Propane Tanks

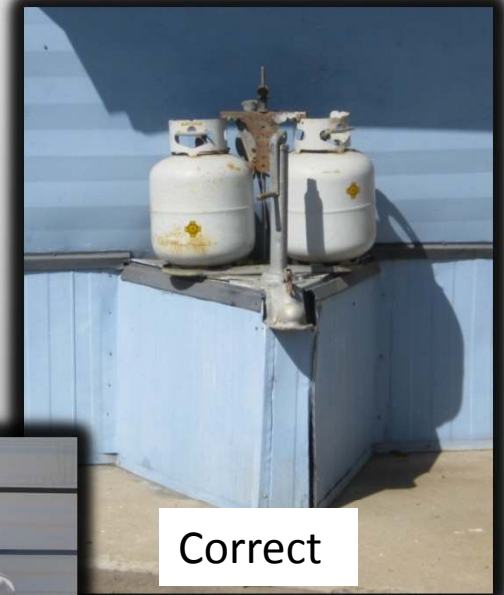
Incorrect

Incorrect

LP-gas vessels are not secured to prevent accidental over turning. Provide an approved method to secure and support LP-gas containers and vessels. (e.g. secured to the unit's hitch, a support post, or other approved means) [25CCR 1208, 1211]

Correct

Correct
